SUBJECT: JOSEPH M. FARLEY NUCLEAR PLANT, UNITS 1 AND 2, ISSUANCE OF
AMENDMENT REGARDING MINIMUM CONDENSATE STORAGE TANK LEVEL
TECHNICAL SPECIFICATION (TAC NOS. ME9293 AND ME9294)

SAFETY EVALUATION BY THE OFFICE OF NUCLEAR REACTOR REGULATION

JOSEPH M. FARLEY NUCLEAR PLANT, UNITS 1 AND 2

Figure 1 - Farley Condensate Storage Tank Suction Pipe Configuration
(Farley Drawing Number 72-4859)

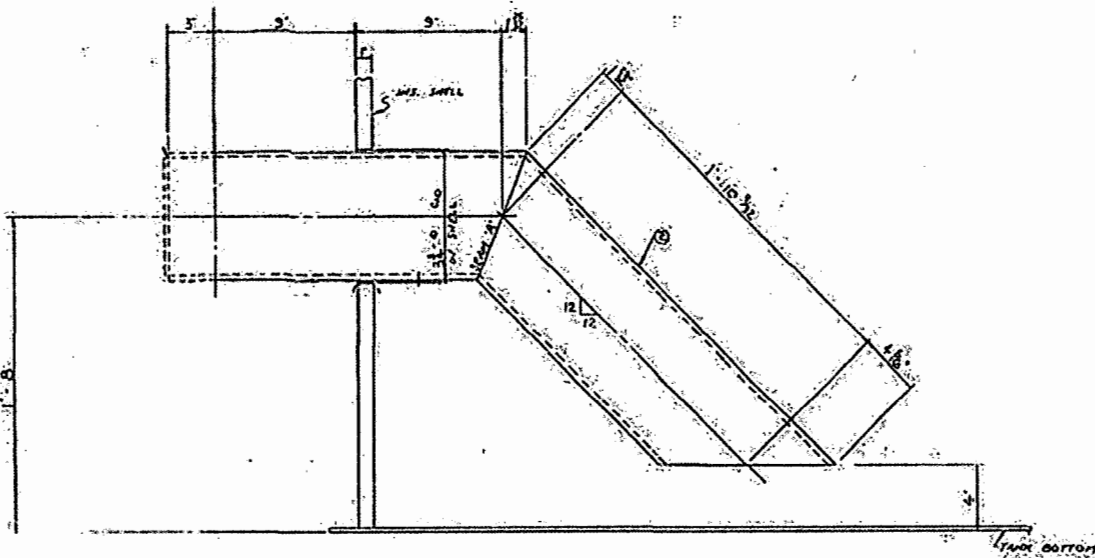
The licensee responded by letter dated October 25, 2012. SNC stated that the critical submergence was calculated using [] (Harleman, 1959).⁵ The Harleman correlation was developed for a vertically downward configuration (referred to in this SE as the Harleman configuration). The Harleman configuration differs from the 45 degree upward flow pipe installed at FNP. The FNP CST Suction Pipe Configuration is provided in Figure 1.

The Harleman configuration was stated to increase “the submergence level by a factor of two over the submergence level for a 45 degree angle pipe or elbow nozzle facing downward.” Using that information, the licensee calculated a critical submergence of 5.78 inches and stated that the minimum allowable submergence was therefore 9.78 inches from the bottom of the tank which includes the four inches of unusable volume below the suction nozzle.
